APPLICATION NO.	FILING DATE	FIRST NAMED INVENTOR	ATTORNEY DOCKET NO.	CONFIRMATION NO.
10/632,433	07/31/2003	William Andrew Decanio	HI02001USU1 (P01018USU1)	2856
	7590 01/10/2008	EXAMINER		
Jennifer H. Hammond The Eclipse Group			CHAN, KO HUNG	
10453 Raintree Lane Northridge, CA 91326			ART UNIT	PAPER NUMBER
			3632	
•				
			MAIL DATE	DELIVERY MODE
			01/10/2008	PAPER

Office Action Summary		Application No.	Applicant(s)		
		10/632,433	DECANIO ET AL.		
		Examiner	Art Unit		
		Korie H. Chan	3632		
	The MAILING DATE of this communication appears on the cover sheet with the correspondence address Period for Reply				
A SHO WHIC - Exter after - If NO - Failur Any r	ORTENED STATUTORY PERIOD FOR REPLY CHEVER IS LONGER, FROM THE MAILING DA sisions of time may be available under the provisions of 37 CFR 1.13 SIX (6) MONTHS from the mailing date of this communication. period for reply is specified above, the maximum statutory period w re to reply within the set or extended period for reply will, by statute, eply received by the Office later than three months after the mailing and patent term adjustment. See 37 CFR 1.704(b).	ATE OF THIS COMMUNICATION 36(a). In no event, however, may a reply b

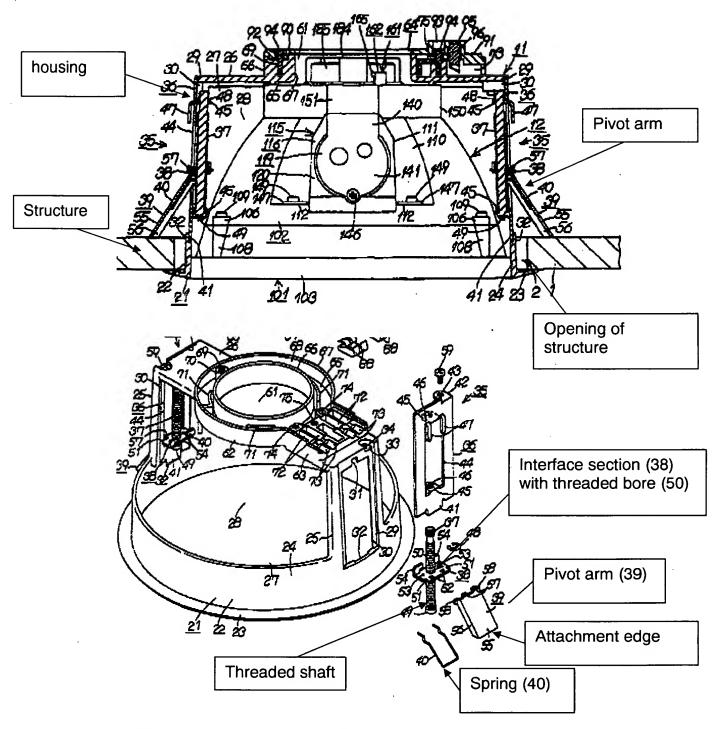
Claims 3, 5-14,17-23, 25-26, and 34-43 are rejected under 35 U.S.C. 103(a) as being unpatentable over Sato et al (US patent no. 6,132,069) in view of Tchilinguirian (US patent no. 6,588,543). Sato discloses a mounting mechanism having all the claimed features of applicant's invention as illustrated below.

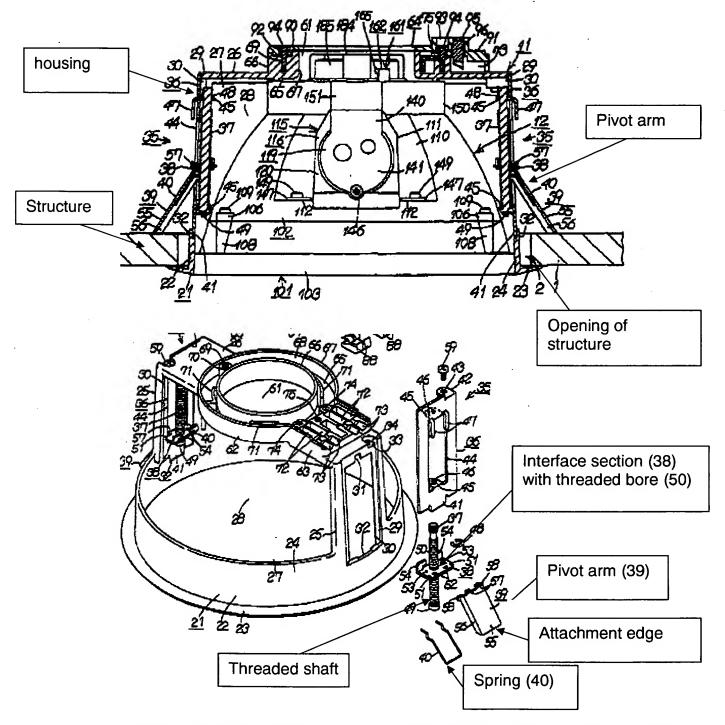
However, Sato does not disclosed the housing is part of a speaker to support a speaker system and wherein the arm as having an attachment edge with toothed attachment surface. Tchilinguirian teaches that mounting brackets for speakers, lights

are well-known in the art and are in the same mounting environment. These prior art mounting brackets are sometimes custom fabricated to make them fit into ceilings and walls of a building structure into which the devices are to be installed (Col. 1, paragraph 2). Furthermore, Tchilinguirian teaches that the mount for speakers (12) can be modified into different configurations for retaining and securing lights, alarms, sensors or other flush mounted equipment not shown (col. 4, lines 42-49). Tchilinguirian further discloses that mounting of a speaker system (that may be round, figure 9) where a speaker housing (48) having mounting structure with arm member (42) having toothed attachment surface (figure 4). It would have been obvious to one of ordinary skill in the art to have modify the system of Sato to mount a speaker system as mounting for speakers can be modified to mount lightings or vice versa as taught by Tchilinguirian. Further it would have been obvious to one of ordinary skill in the art to modify the attachment edge of Sato's arm such that it is toothed for the well-known advantage of digging into the structure for firm attachment as taught by Tchilinguirian.
